Docket Item # 6
BAR CASE # 2017-00360

BAR Meeting
October 18, 2017

ISSUE: Alterations (Window Replacement)

LOCATION: 312 North Columbus Street

Figure 1. Front elevation of 310 (left) and 312 (right) North Columbus Street with the townhouse on the left retaining its original 2/2 wood windows.

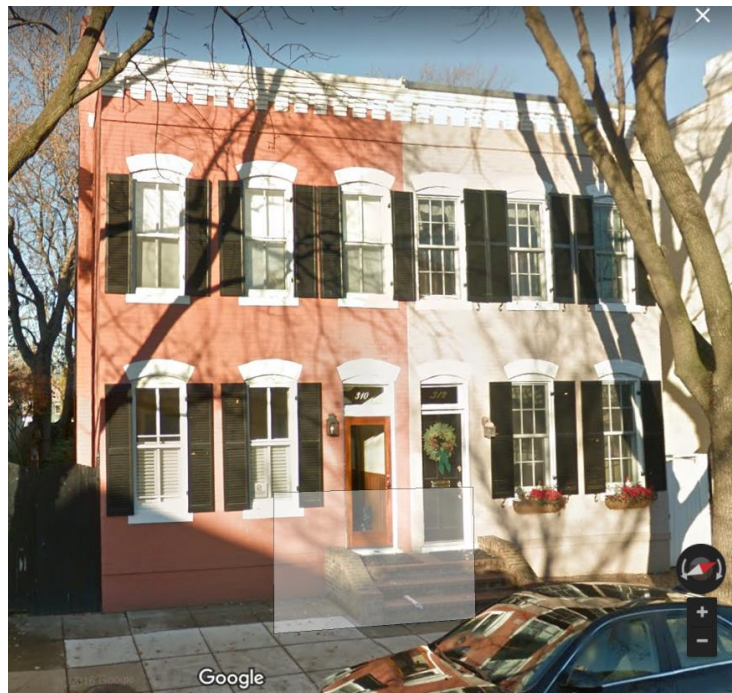
In visiting the property while preparing this report, staff observed that the style of the 6/6 windows on the front (east) elevation are not historically correct for this dwelling. As confirmation, the other half of this semi-detached pair of townhouse retains its original 2/2 wood windows (Figure 1). The BAR's *Design Guidelines*, adopted in 1993, state: "New and Replacement windows should be appropriate to the historic period of the architectural style of the building. For example, two-over-two and two-over-one windows are appropriate on Victorian Style buildings dating from the late-19th to early 20th century. Multi-paned windows are not appropriate on structures dating from this period." (Windows – Page 2)

Furthermore, the existing replacement windows at 312 North Columbus Street have simulated divided lights (SDL), where the muntin pattern is permanently affixed to both the interior and exterior of a single panel of insulated glass in each sash. SDL glazing has only been commonly available for approximately the past 10 years. The BAR's current Window Policy, adopted in 2010, states that: "Double glazed (insulated) and simulated divided light painted wood windows may be used throughout on buildings or additions constructed after 1930, when Thermopane brand insulated glass windows were invented." The policy goes on to clarify, however, that: "1-over-1, or 2-over-2 sash windows...may be replaced with double glazed painted wood windows on any façade."

Staff was unable to locate any prior approvals for replacement windows at this property. Therefore, staff strongly encourages the applicant to replace the inappropriate, non-complying windows with 2/2 painted wood windows or sash kits to match the adjacent historic windows, noting that 2/2 sash may be double-glazed and can be administratively approved per the present Window Policy.
